Appl. No.: 10/647,488  
Amdt. Dated August 23, 2006  
Reply to Office Action of February 23, 2006

### **Amendments to the Drawings**

FIGURE 1

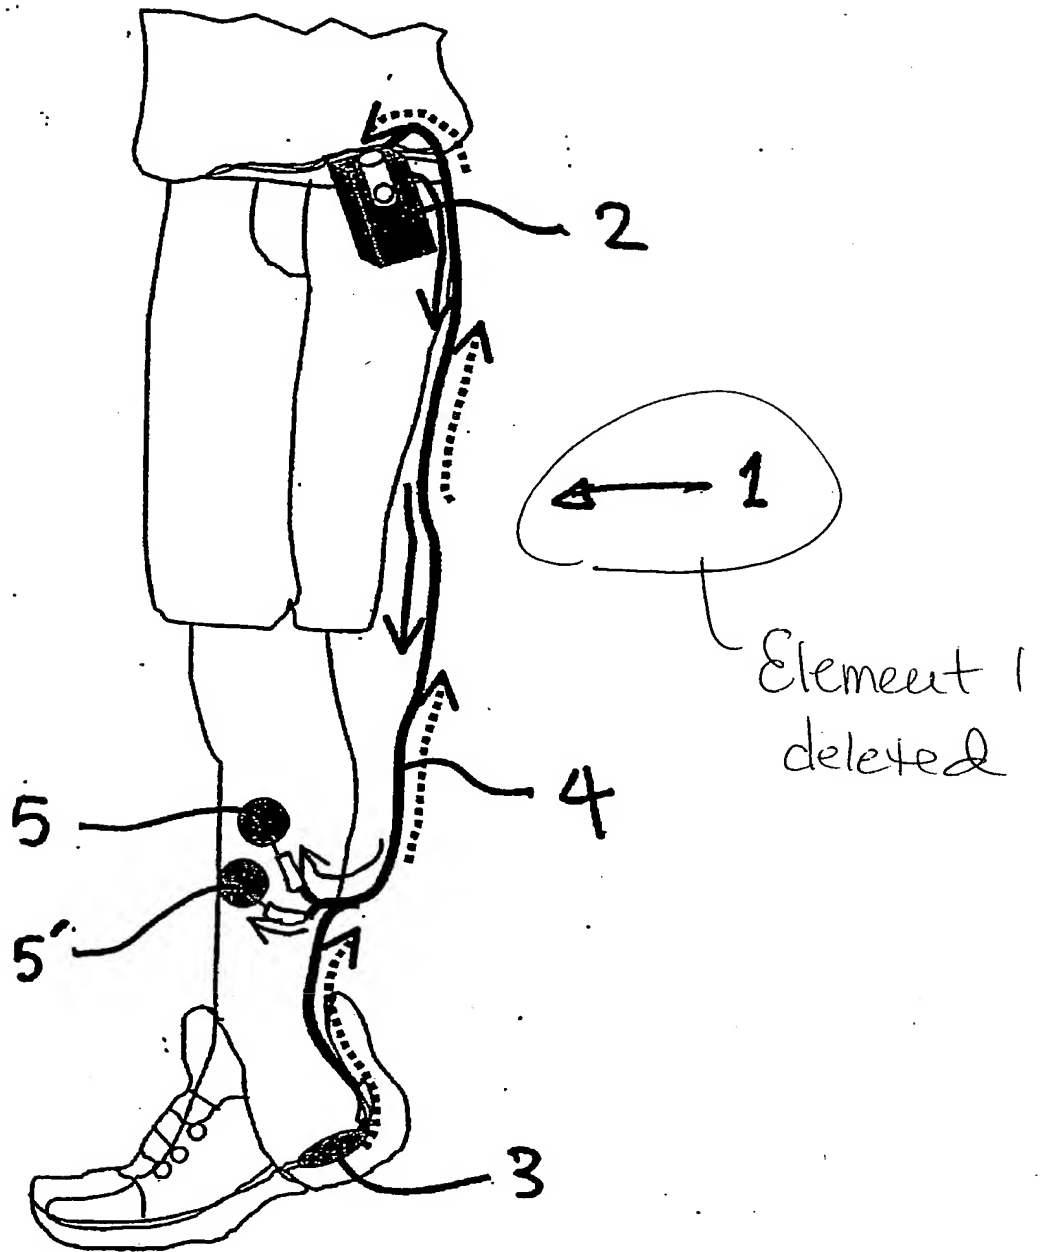
The attached one (1) sheet of drawings that includes Figure 1 will replace the sheet of drawings as originally filed. On the one (1) enclosed replacement sheet that includes Figure 1, element 1 has been deleted.

Enclosed is one (1) Replacement Sheet including Figure 1, which is amended to delete element 1. An Annotated Drawing Sheet is included with this submission.
